Proposal Request

PROJECT: *(name and address)*
AWSOM
Bentonville, Arkansas

PROPOSAL REQUEST 039

MSE Walls, Curbs, and Grading

1 MSE WALL - ENLARGED PLAN
1/8" = 1'-0"

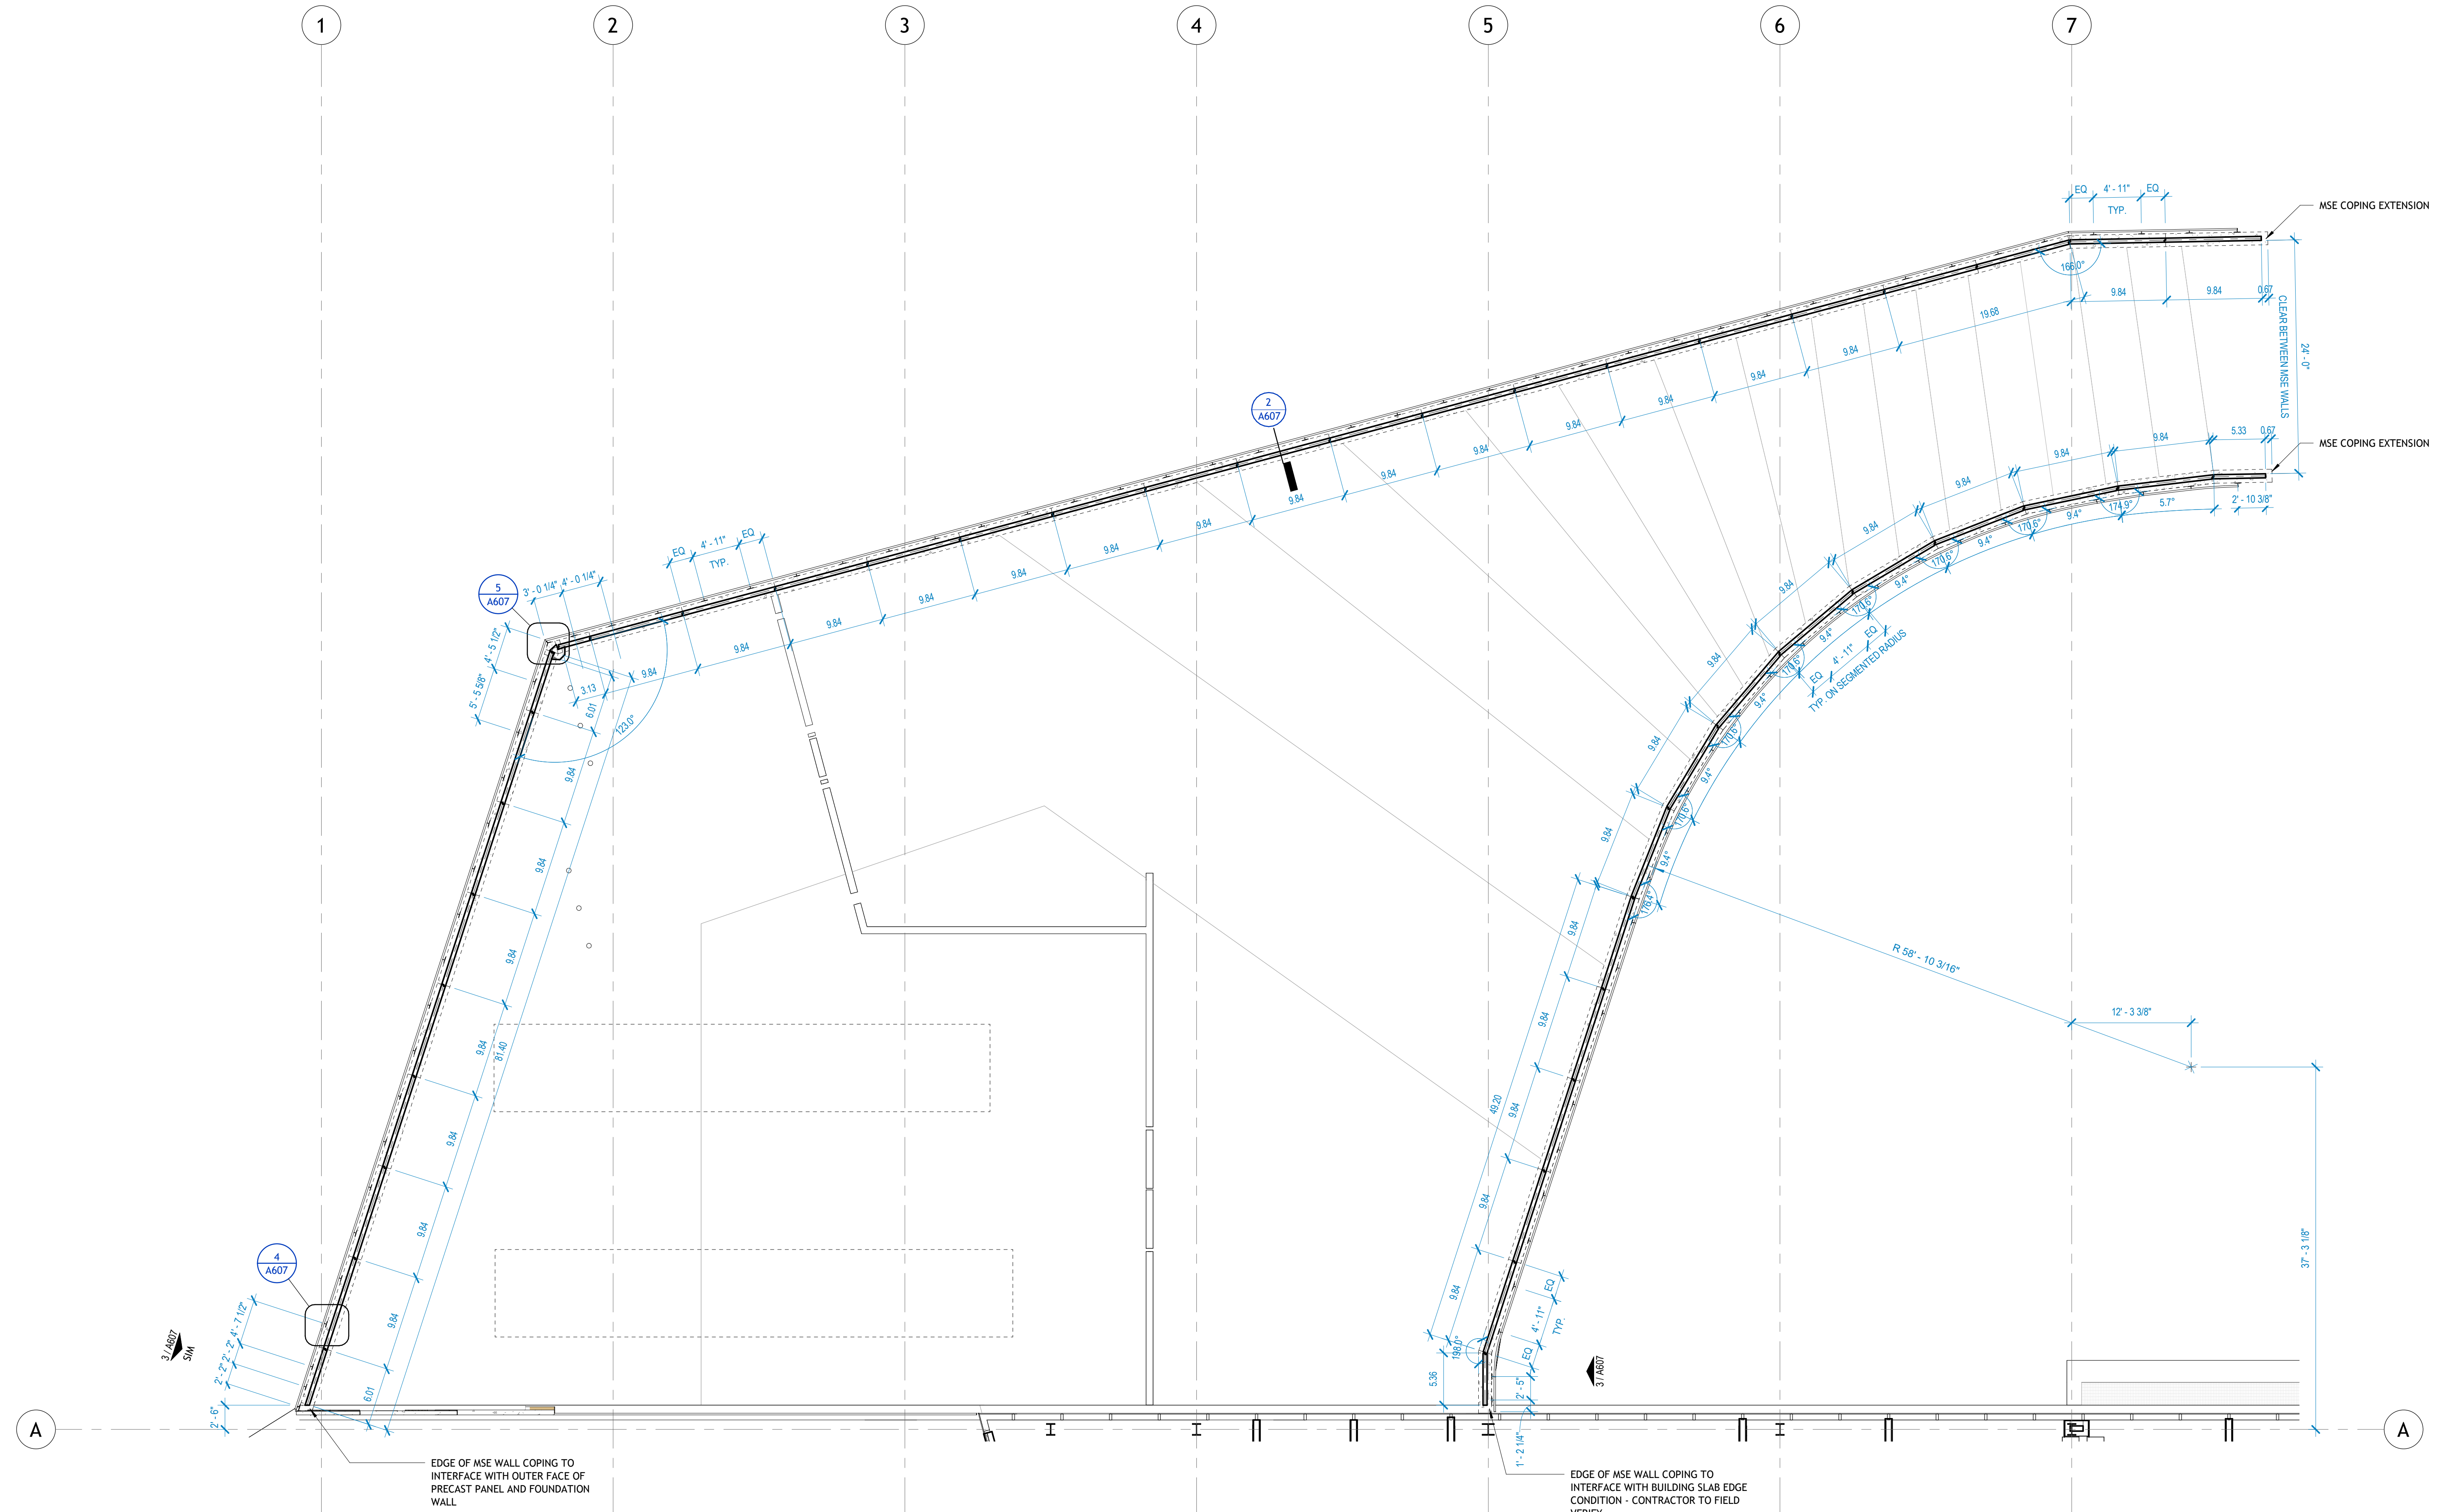
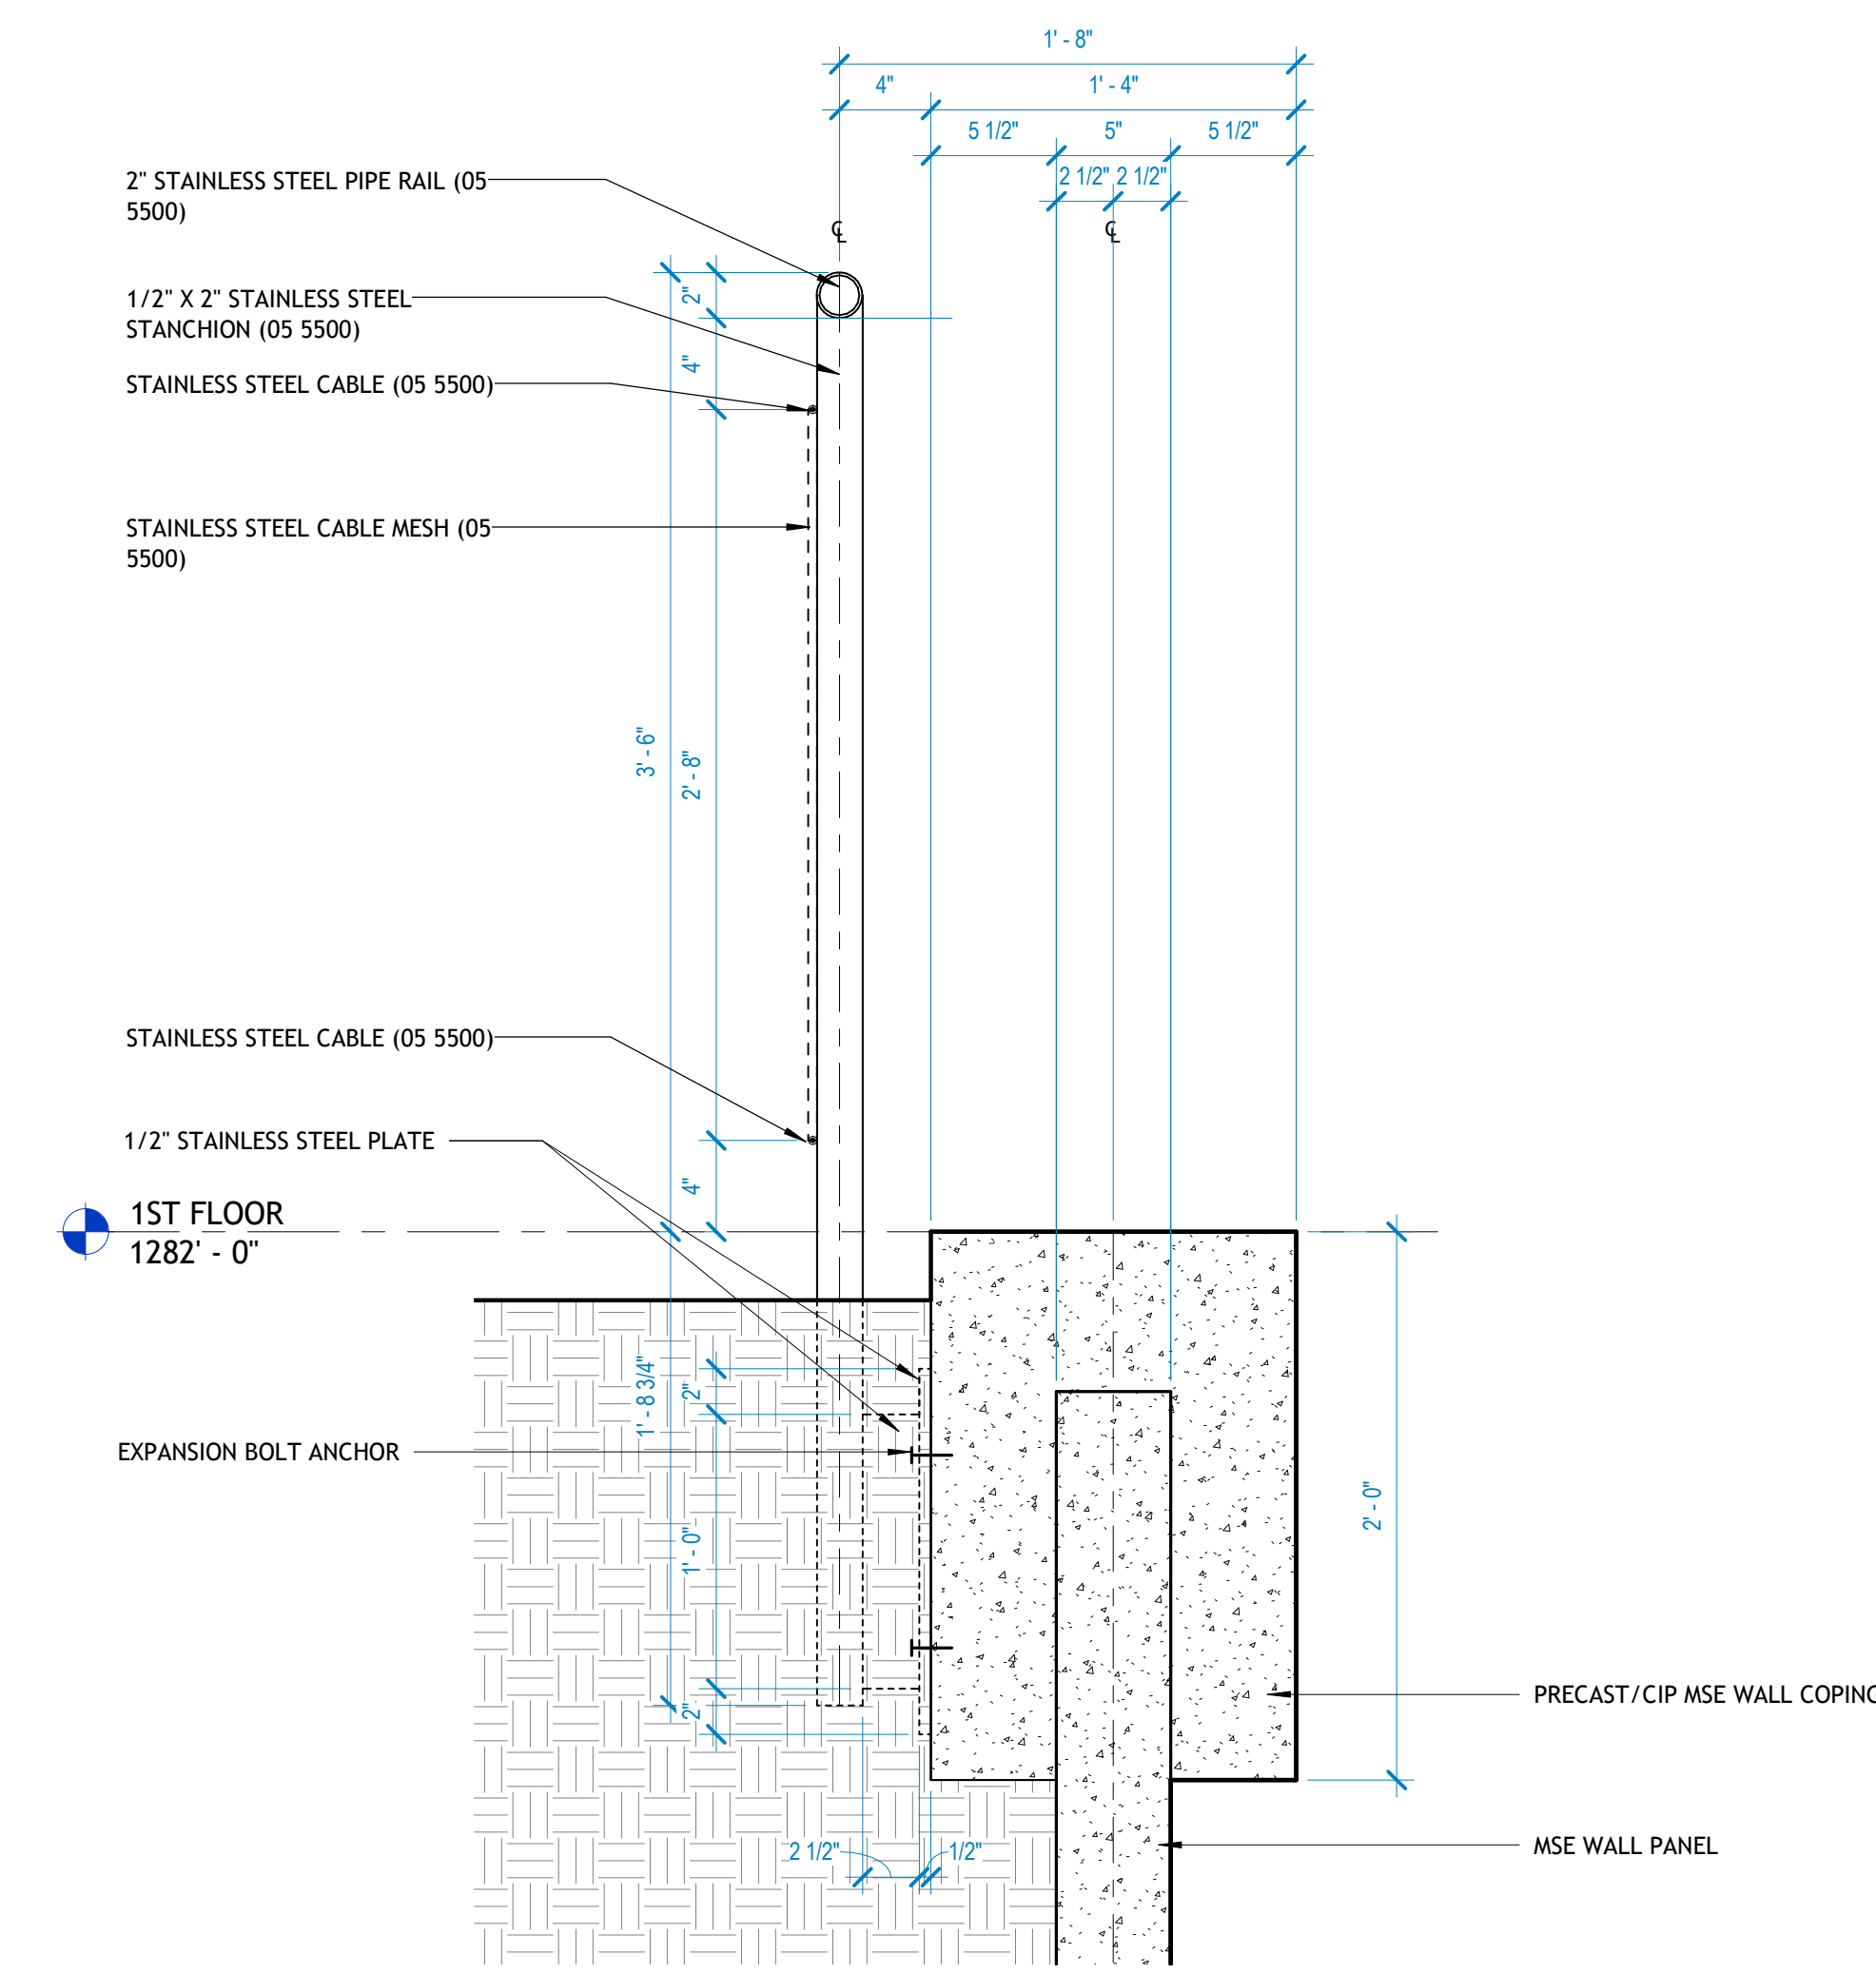
- a) Refer to Revised Sheet **A100AD**, with original issue date 02.24.2023 and revised date 04.04.2024.
 - Dimensions on MSE wall revised.
- b) Refer to Revised Sheet **A100BD**, with original issue date 02.24.2023 and revised date 04.04.2024.
 - Dimensions on MSE wall added.
 - Note on landscaping curb added.
- c) Refer to Revised Sheet **A101A**, with original issue date 02.24.2023 and revised date 04.04.2024.
 - Notes on MSE walls omitted.
- d) Refer to Revised Sheet **A101B**, with original issue date 02.24.2023 and revised date 04.04.2024.
 - Notes on MSE walls omitted.
- e) Refer to New Sheet **A607**, with original issue date 04.04.2024.
 - New MSE wall layout added.
 - New guardrail details added.
